TITLE: **CHANGE OF CUSTOMER'S DRAWING**
**TBK : CHANGED DRAWING OF CASE ASSY, TIMING CHAIN  
BY ELIMINATE O-RING GROOVE FOR COST REDUCTION(MZK)**

**TBK HAS CHANGED THE DRAWING OF CASE ASSY, TIMING CHAIN  
COVER OIL PUMP.**

PART NO.: 1060A196, 1060A217,

件名/TITLE  
4N15 COVER, OIL PUMP DELETE O-RING GROOVE.

&lt;1&gt; DWG NO. 1211A167 COVER, OIL PUMP (P/No.1211A166)

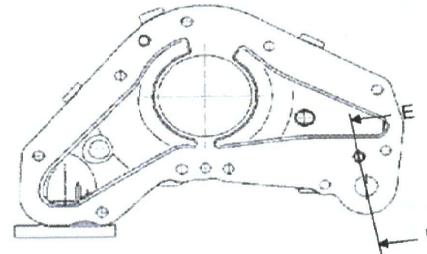
## 1.1 DELETE GROOVE OF O-RING.

<2> DWG NO. 1211A169 COVER ASSY, OIL PUMP (P/No.1211A168)

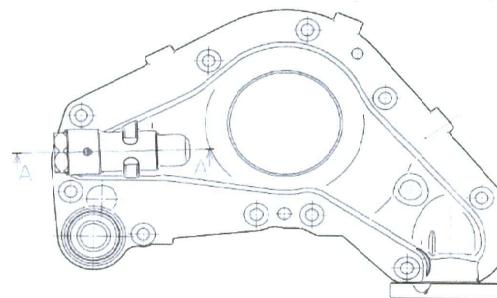
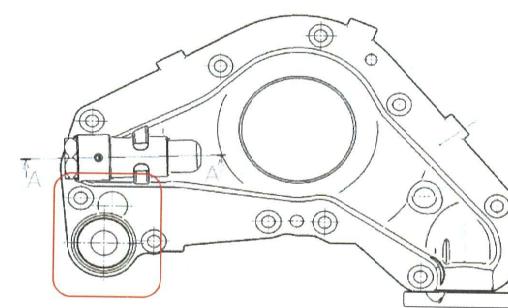
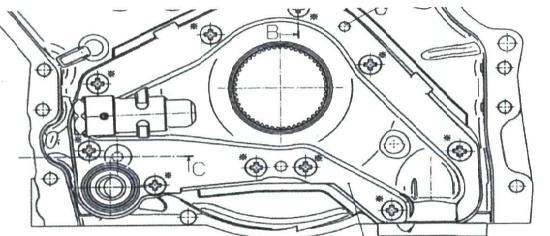
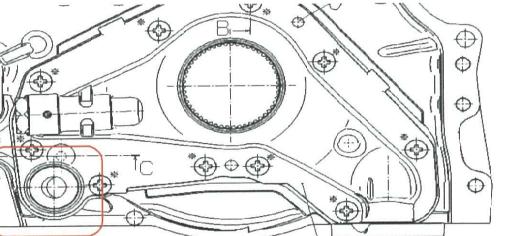
**2.1 CHANGE SHAPE OF COVER , OIL PUMP.**
**WAS**

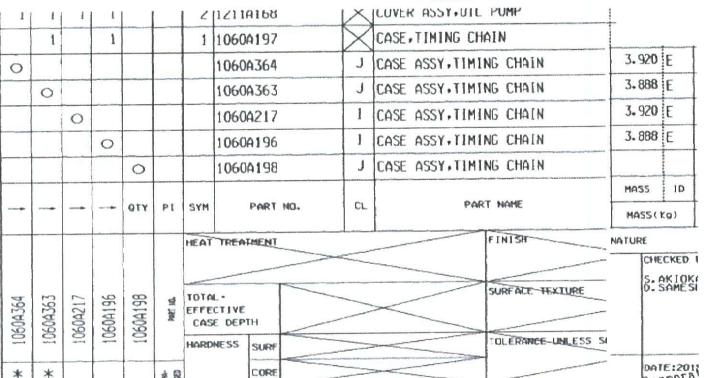
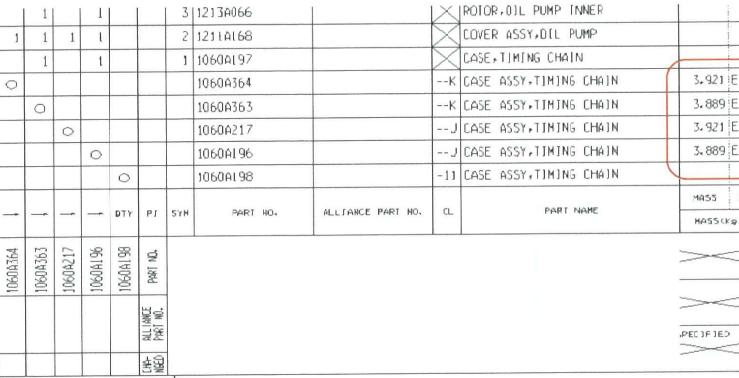
**2.2 CHANGE OF MASS.**
**WAS**

<2> DWG NO. 1211A169 COVER ASSY, OIL PUMP (P/No.1211A168)  
2.1 CHANGE SHAPE OF COVER , OIL PUMP.

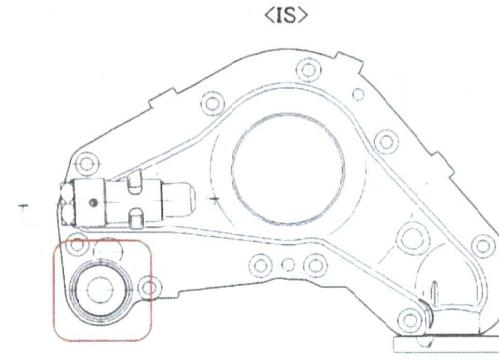
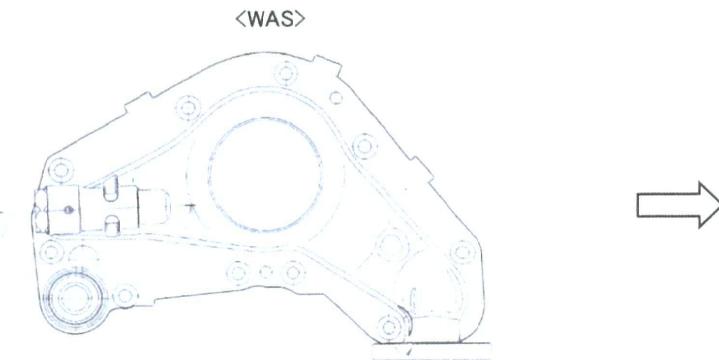
## 2.2 CHANGE OF MASS.
